SHARP SERVICE MANUAL

No. S2509GX25SPL/

SUPPLEMENT

DIGITAL MOBILE PHONE MODEL GX25

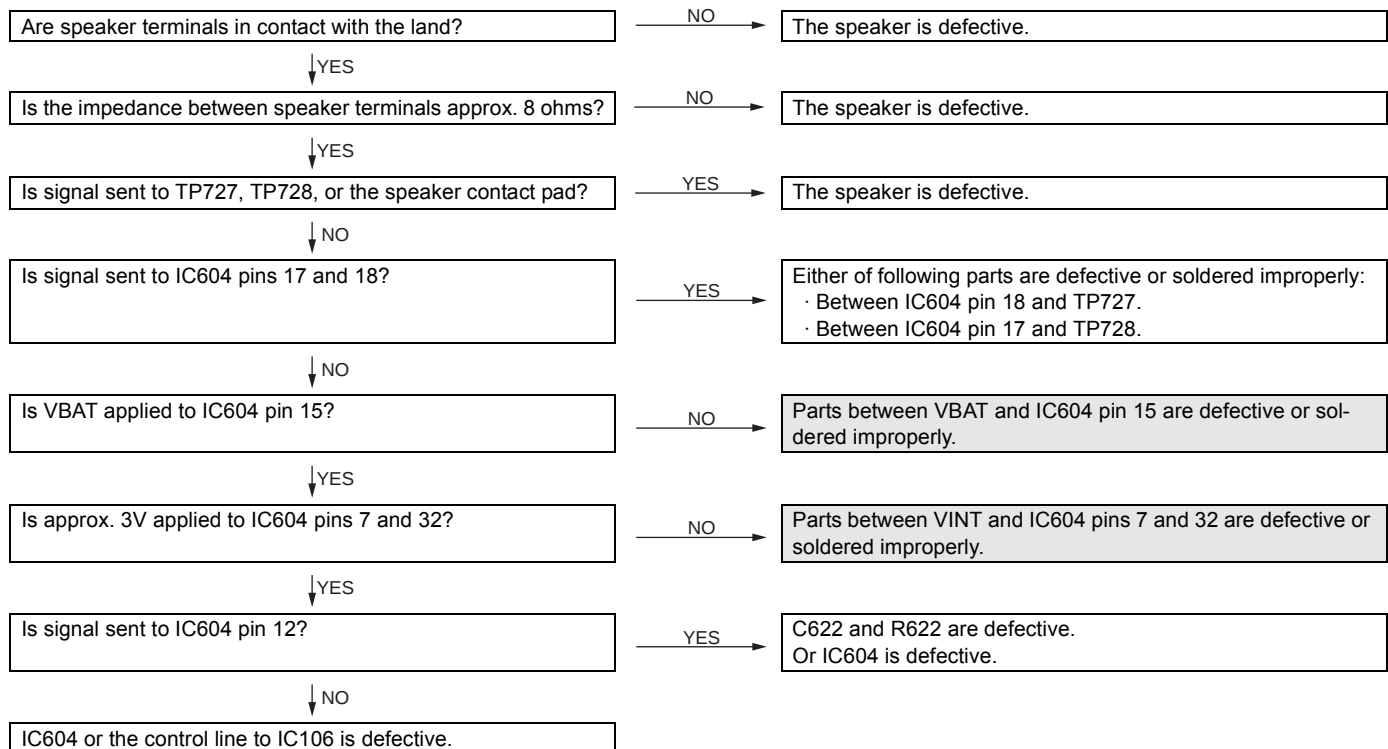
- Confirm the differences with GX25 (Old P.W.Board).

Figure 2 SCHEMATIC DIAGRAM (2/6)

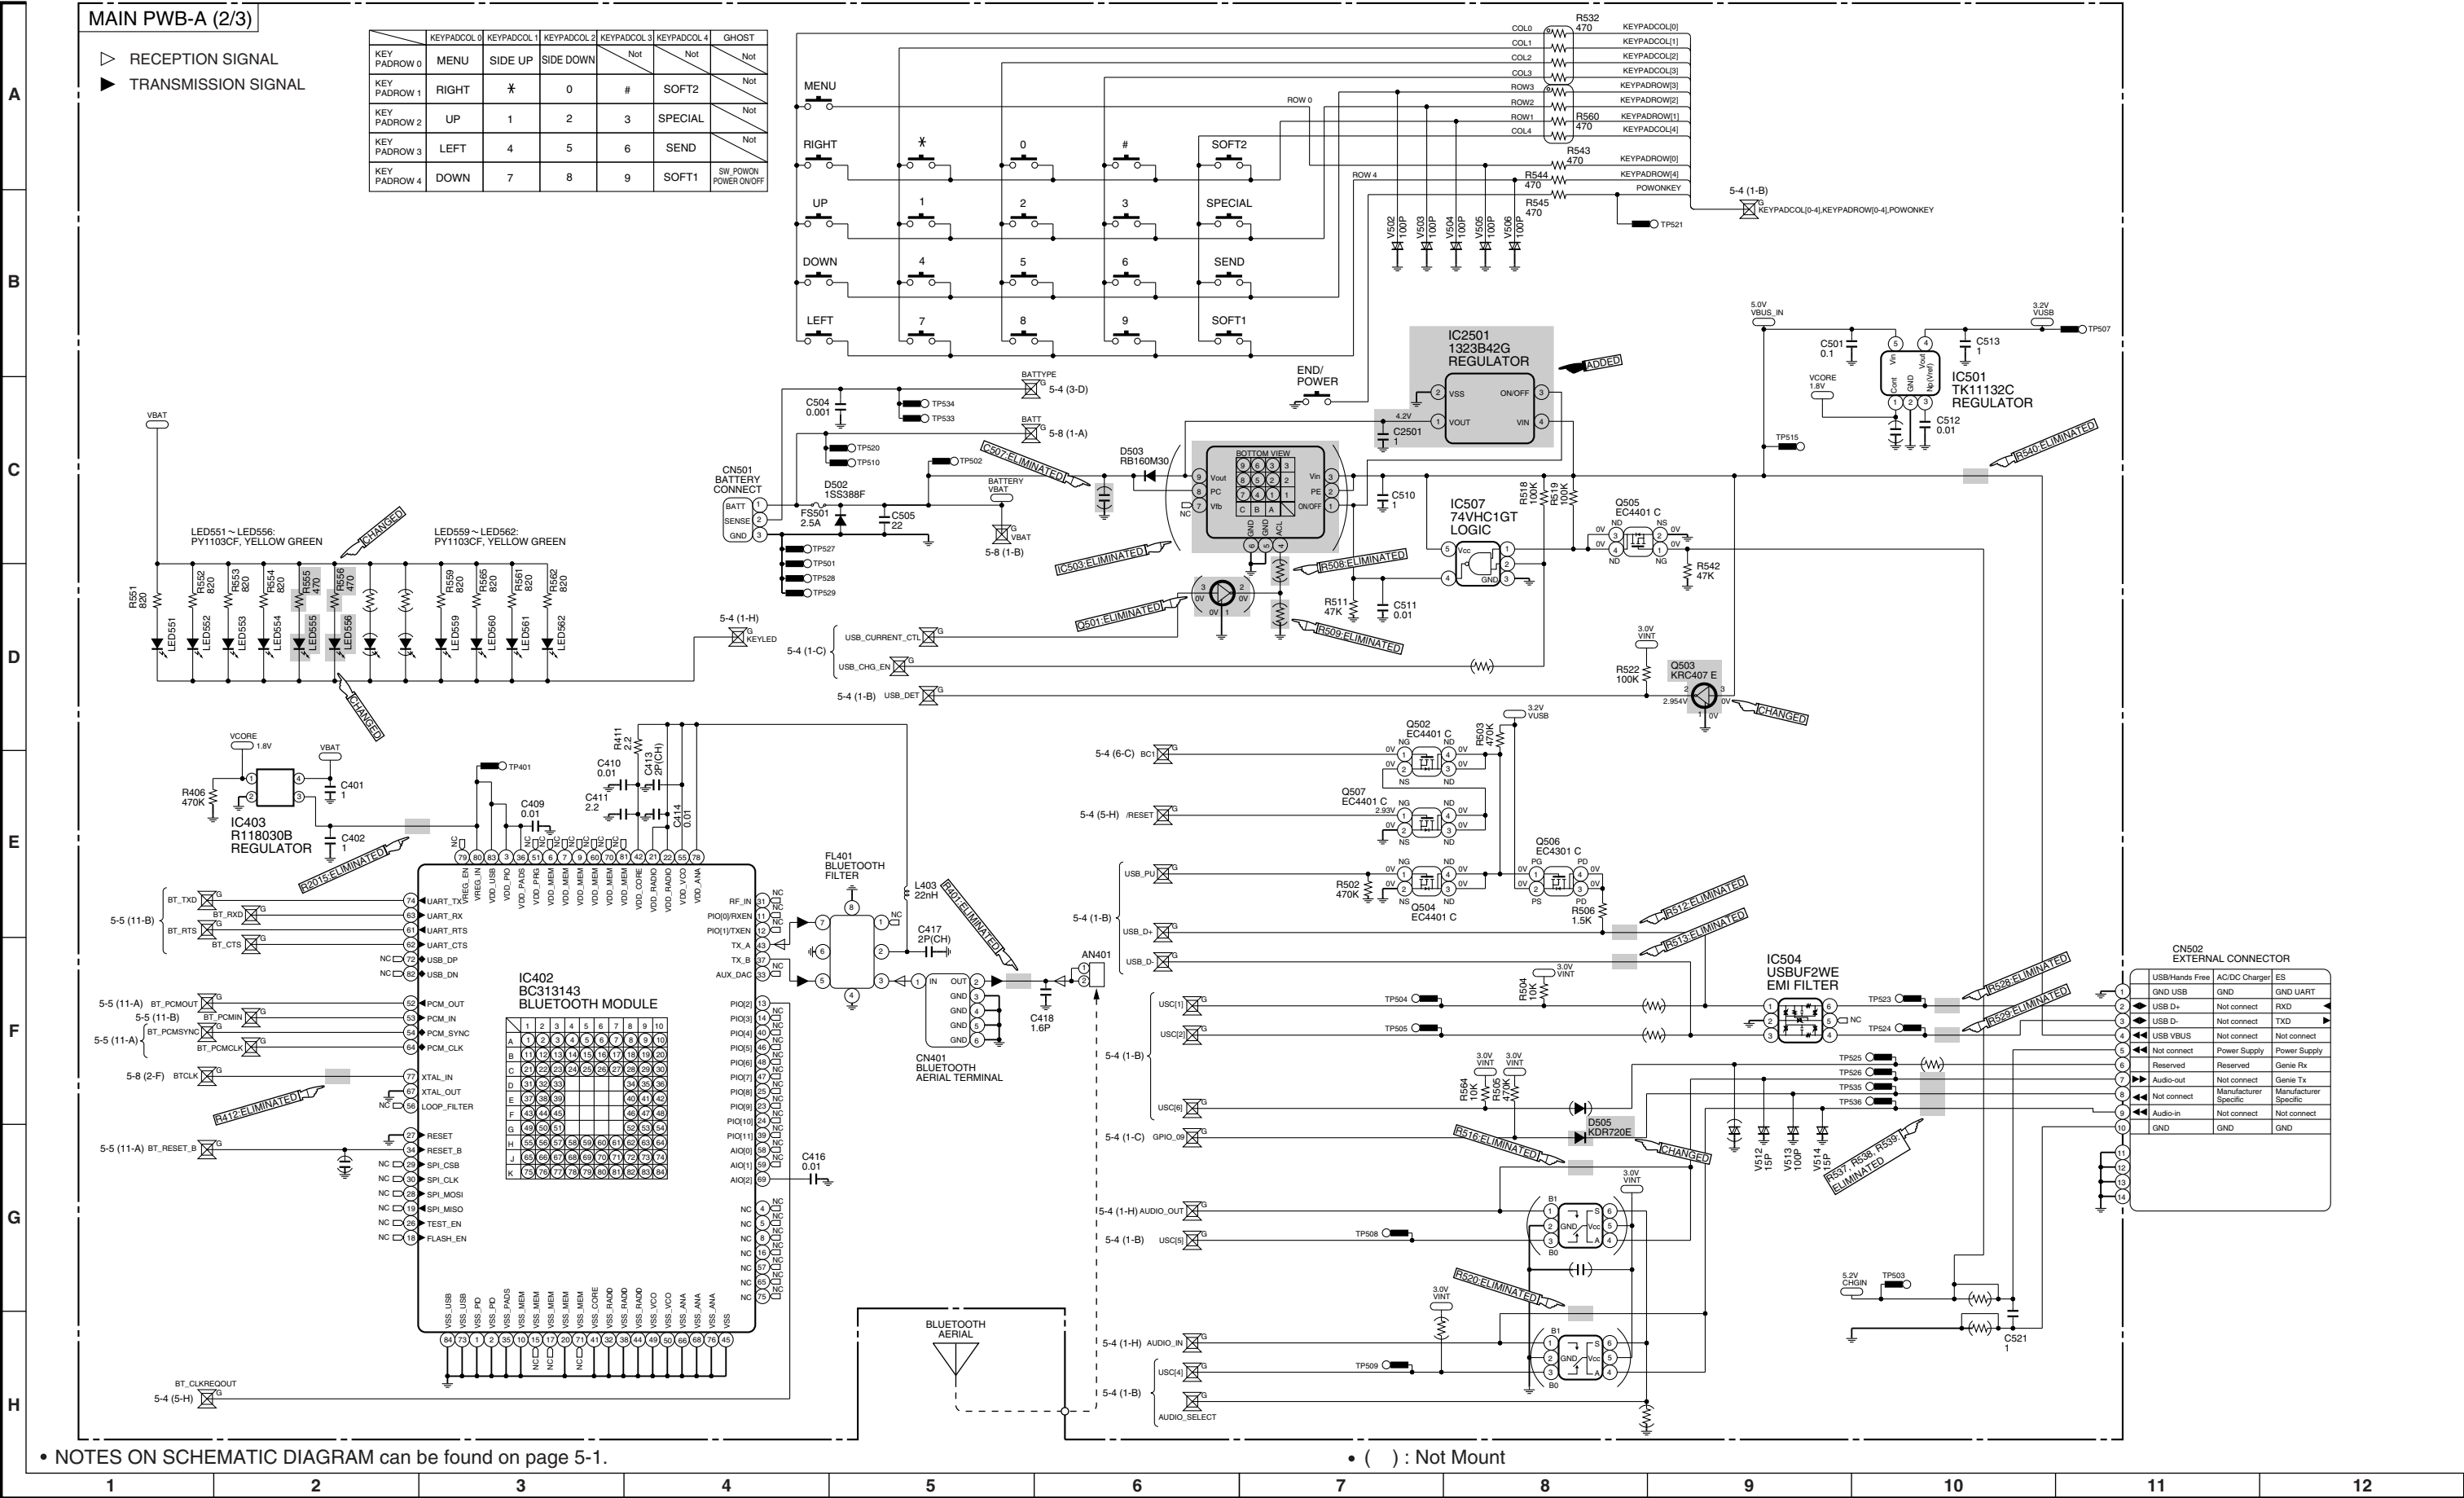
• Confirm the differences with GX25 (Old P.W.Board).

Figure 3 SCHEMATIC DIAGRAM (3/6)

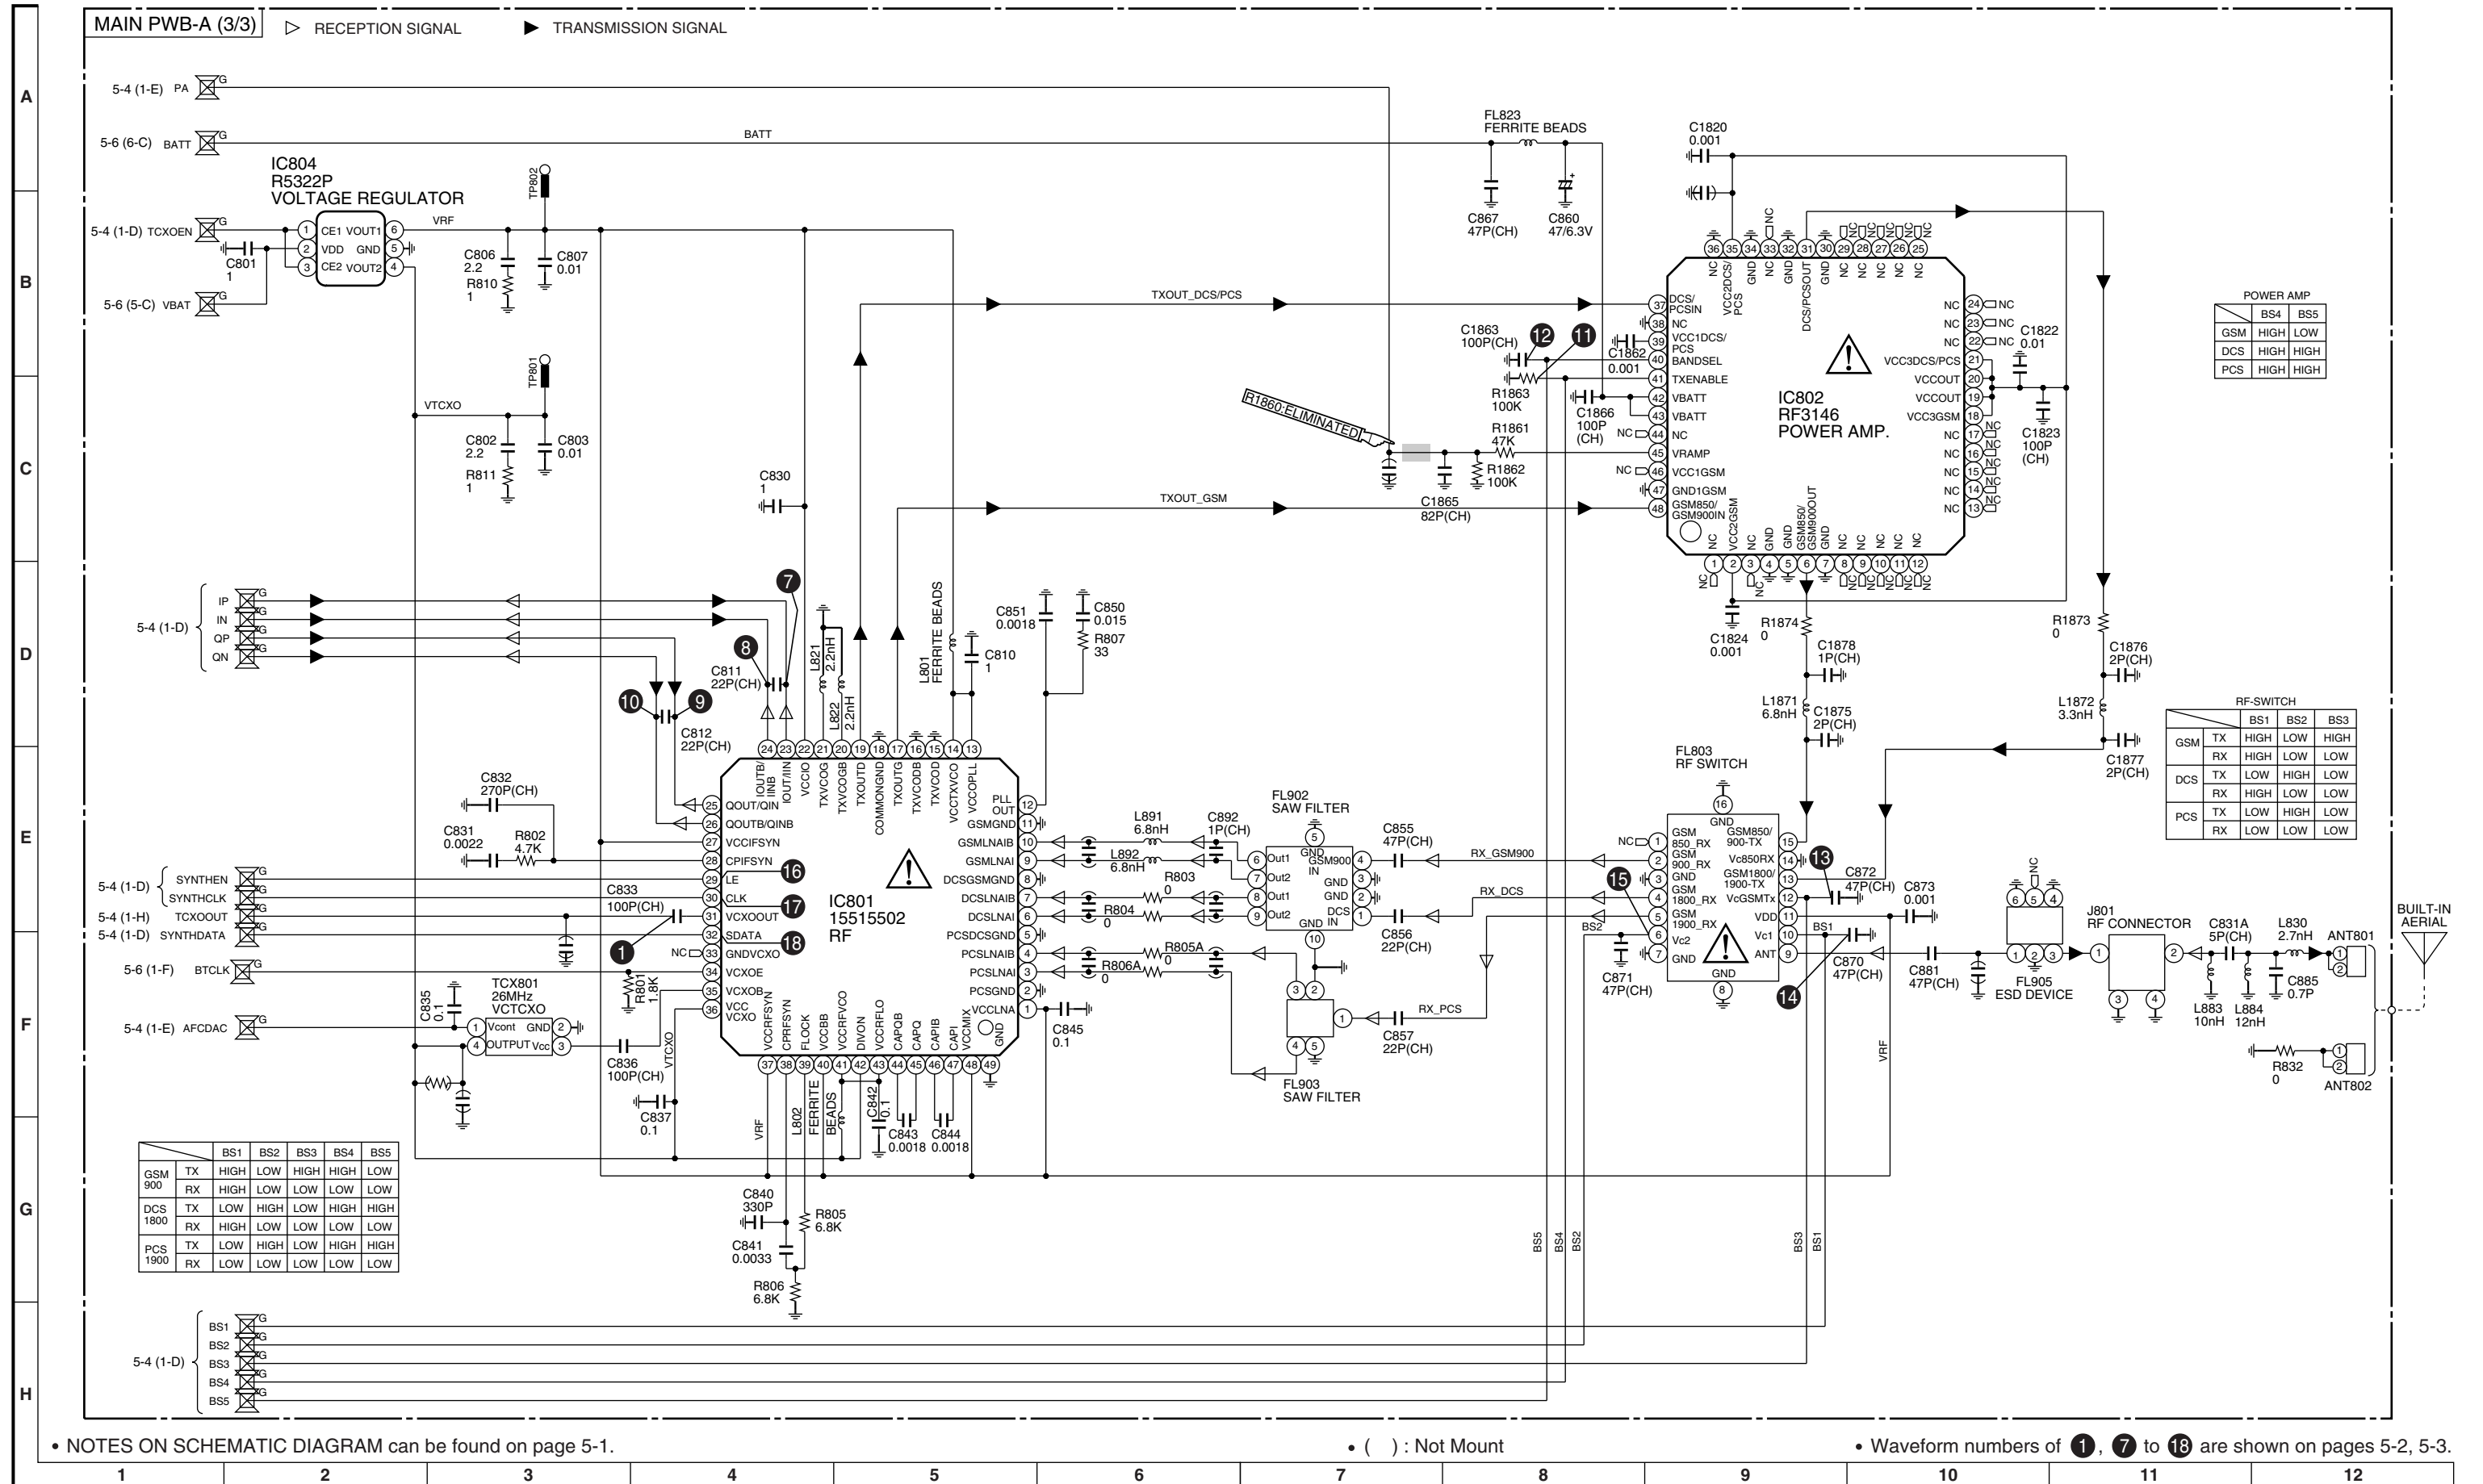
- Confirm the differences with GX25 (Old P.W.Board).

Figure 7 WIRING SIDE P.W.BOARD (3/5)

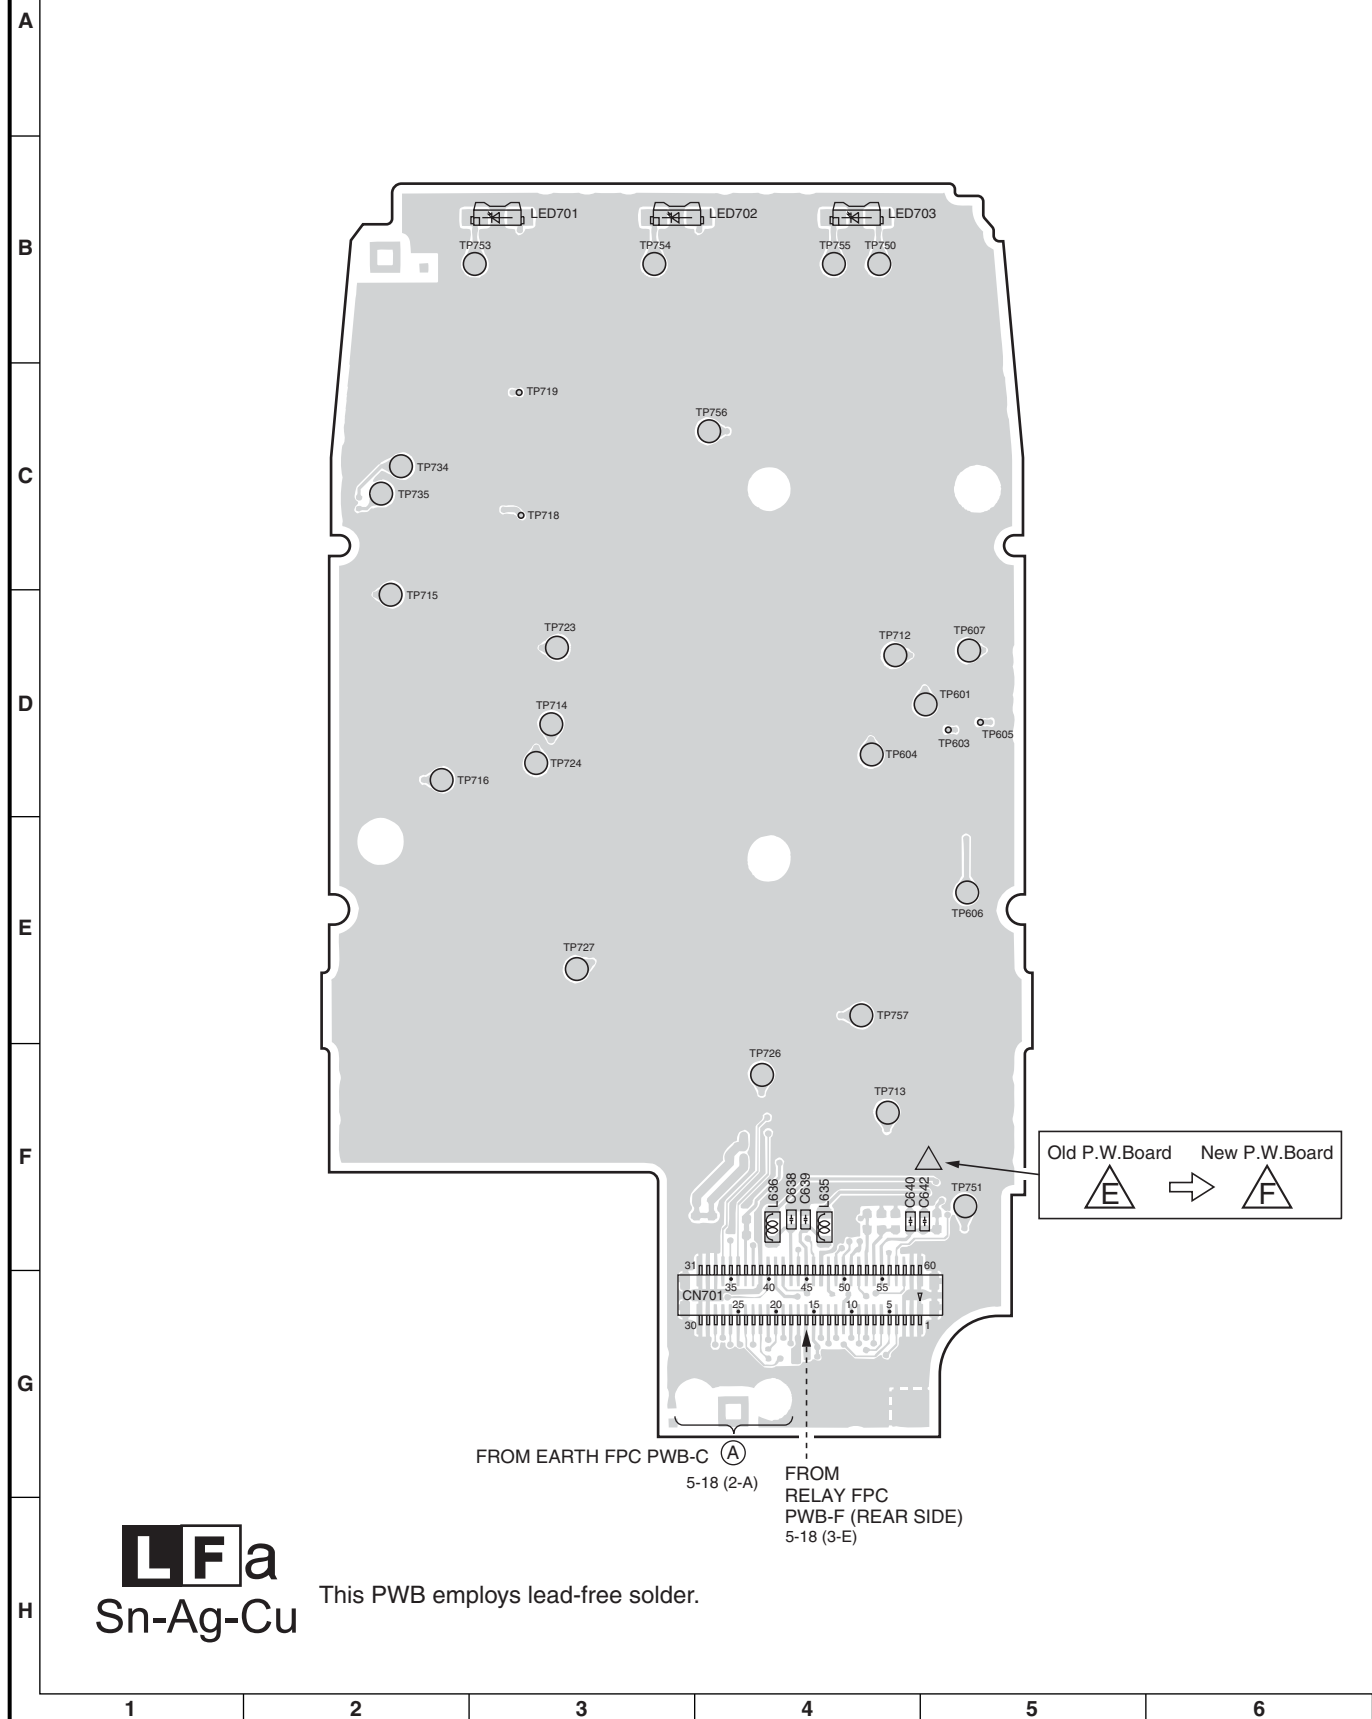
• Confirm the differences with GX25 (Old P.W.Board).
